## RESPONSE TO SUBMISSIONS NOS. 19-27 CROSS STREET, DOUBLE BAY (DA 321/2020)

Thank you for the opportunity to provide amended plans and additional material for the Development Application (DA 321/2020) for the proposed demolition of the existing building and construction of a shop-top housing development at Nos. 19-27 Cross Street, Double Bay.

Source: Luigi Rosselli Pty Ltd  
**Figure 1: Shadow Diagrams**

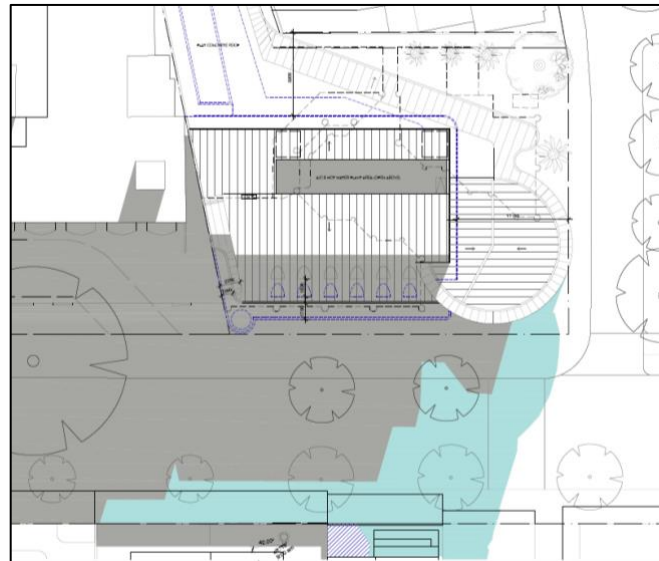
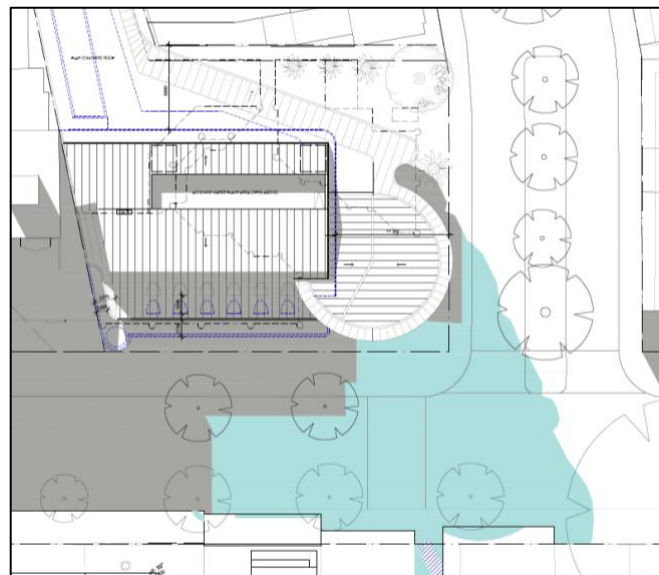
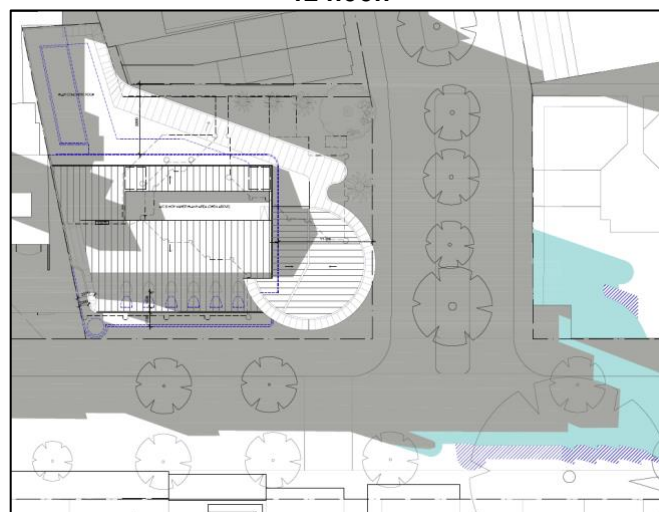
Several of the submissions raise concerns regarding solar access to the proposed plaza, surrounding buildings and the public domain. One submission seems to have misunderstood Council’s shadow diagram requirements and suggests that the shadow diagrams submitted with the DA are insufficient.

Council’s DCP states that solar access should be preserved to the footpath on the southern side of Cross Street and that development should comply with the control drawings to ensure adequate solar access to neighbouring properties. The proposal has been designed to maximise solar access to the north-facing plaza, the southern side of Cross Street and neighbouring properties. As per the shadow diagrams below, solar access will be maintained to the ground floor plaza and the neighbouring properties on Transvaal Avenue. Solar access is generally maintained to the southern side of Cross Street. With the increased setback to the upper levels, an amended roof form and a reduction in overall building height included in the amended plans, solar access to the southern side of Cross Street will be increased when compared to the original DA scheme (see **Figure 1** on the following page). Solar access is further discussed in the SEE submitted with the DA.

The shadow diagrams submitted with the DA include horizontal and vertical shadows cast at the winter solstice (June 21) at 9am, 12pm and 3pm, as per Council's DA Guide. Further, hourly sun eye diagrams between 9am and 3pm have been prepared by the architect.

Accordingly, the proposal will provide solar access to the ground floor plaza and maintain solar access to neighbouring properties on Transvaal Avenue. The amended plans will improve solar access to the southern side of Cross Street when compared to the original DA scheme to provide appropriate solar access to the public domain.
